KOUGLER & ASSOCIATES  
ENVIRONMENTAL SERVICES

Subject: IMC-Agrico Company (New Wales)  
Multifos Plant Production Increase  
DEP File No. 1050059-024-AC, PSD-FL-244

This is in response to your letter dated December 16, 1997, requesting additional information on the above referenced project. The responses are in the order of the questions raised by FDEP and the U.S. Fish & Wildlife Service (FWS).

**ATTACHMENT 1**

PREPARED: CDT	TITLE: PROPOSED MULTIFIDS KILN C	IMC-AGRIGD CO.
DATE: 11/13/97	SCRUBBER FLOW DIAGRAM	LOCATION: NEW WALES
REVISED: 3/4/98		FILE: KILN02
		SCALE: NONE
		DRAWING NO: L5

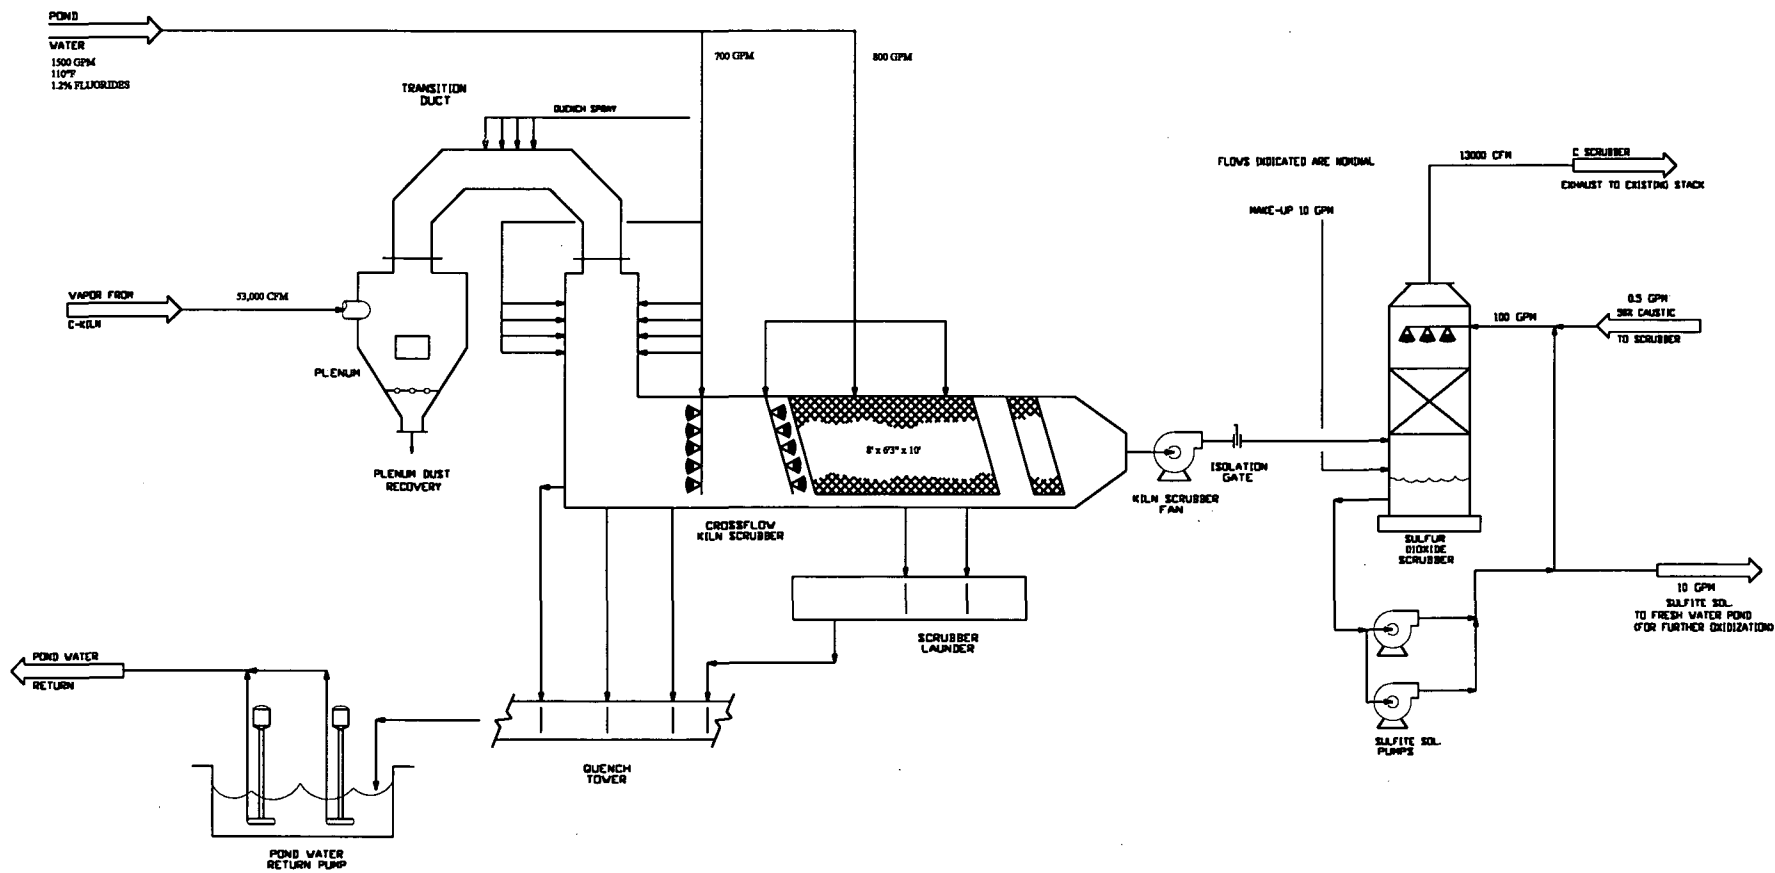
2. Please explain why the SO<sub>2</sub> scrubbing system performance was not specified. SO<sub>2</sub> scrubbing is sufficiently advanced that the reagent and its performance can be specified prior to construction. Also explain the sulfurous acid/stripper system indicated on Drawing L5.

Details of the SO<sub>2</sub> scrubber are provided in Attachment 1. The scrubber performance information from the manufacturer is also included. Please note that the proposed project no longer includes a stripper. A revised drawing is included in Attachment 1.

**PACKED COLUMN**  
INC 001  
872352 RD

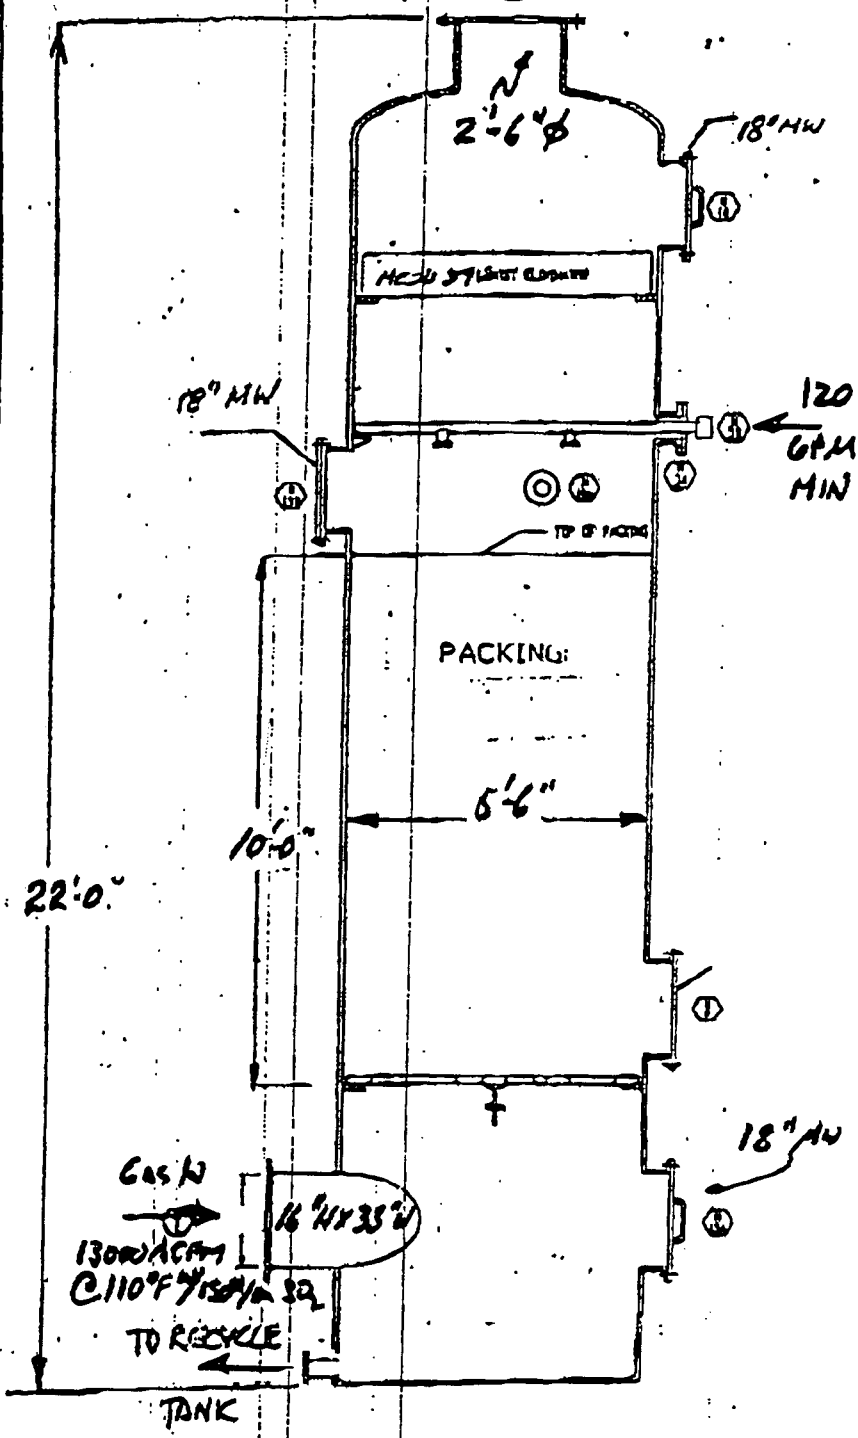
1. A detailed description of the proposed emission control system is needed including control system flow rates (gas and liquid streams), pond water fluoride concentrations and temperatures, and the proposed SO<sub>2</sub> removal efficiency and cost effectiveness calculations. The additional information should be sufficiently detailed to allow a determination of achievable emission levels through mass transfer calculations. A thorough assessment of the cost effectiveness of the various SO<sub>2</sub> control options including a separate countercurrent scrubber vs. the proposed crossflow add-on should be done.

The proposed scrubber system arrangement has been revised after further discussions with the equipment manufacturer. IMC-Agrico proposes to include a counter-current scrubber, with a manufacturer guaranteed SO<sub>2</sub> control efficiency of 95 percent. Based on this level of control, the net SO<sub>2</sub> emissions increase from the proposed project will be less than significant. Therefore, the proposed project is no longer subject to PSD applicability for SO<sub>2</sub> (see attached calculations). Accordingly, please disregard the previously submitted information on BACT and air impact analysis for SO<sub>2</sub>. The available information on the proposed scrubber system is presented in Attachment 1.
